Proposed Cringila emplacement : environmental impact
assessment

ENVIRONMENTAL IMPACT
ASSESSMENT

DEPARTMENT OF ENVIRONMENT & PLANNING
SYDNEY, 1982

**Figure 6
PROPOSED COMPLETED
LANDFORM (as amended)**

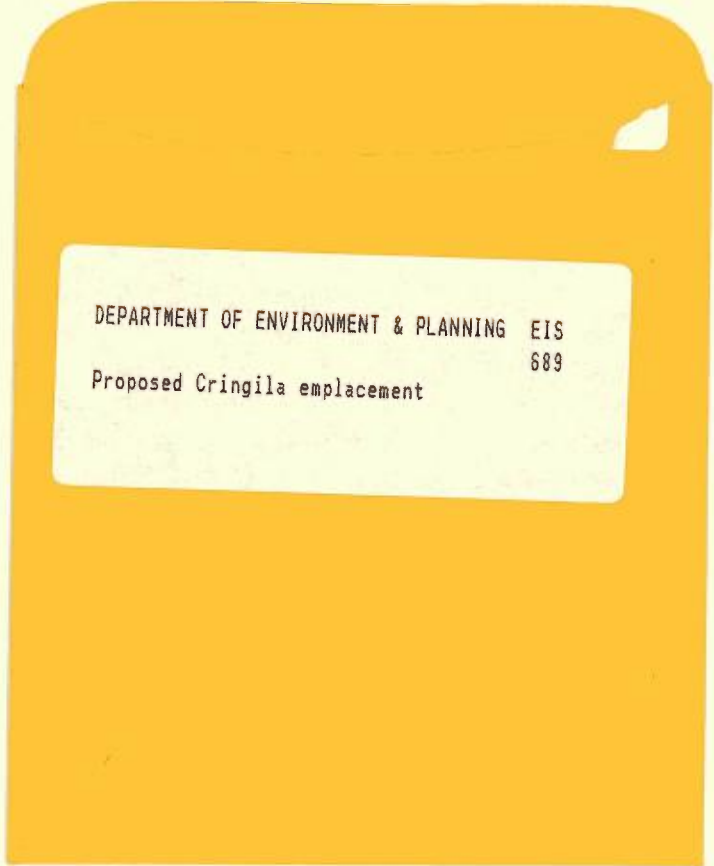
Following lodgement of the development application and environmental impact statement to Wollongong City Council, Council suggested some amendments to the landform layout of the final emplacement. The proposal was consequently altered for A.I. & S. by Longworth and McKenzie Pty. Ltd. The new concept involves a final landform providing for two playing fields closer to the existing fields in the north of the site. In achieving this new landform, the capacity of the emplacement has been reduced from 4.2 to 3.6 million cubic metres. The new concept is illustrated in Figure 6. A.I. & S. has not committed itself to any particular strategy regarding access to the rehabilitated site or type of recreational facilities to be provided.

A.I. & S. propose that the rehabilitated landform would be used for a mixed recreational facility. Wollongong City Council has indicated to the Department (by letter dated 15 July 1982) that there is a need for further recreational facilities at Cringila. As indicated in Section 3.9 of this Report, plans for the final landform and facilities have been altered since lodgement of the development application and environmental impact statement. A.I. & S. and the Council have reached agreement on the new landform.

9.3 That in the event that A.I. & S. can satisfy the Commission of Inquiry that a suitable alternative site cannot be made available or could not practicably be established in the time available, the Cringila emplacement, as described in the environmental impact statement dated November 1979, and as subsequently amended to a smaller ultimate capacity (3.6 million cubic metres) and new completed landform (as shown in Figure 6), be further investigated by the Commission of Inquiry. In the unlikely circumstance that a better alternative site cannot be found, then the Department would be willing to recommend to the Commission of Inquiry an appropriate set of conditions for a proposal that would result in a smaller ultimate capacity in the form suggested in Section 3.9 of this report.
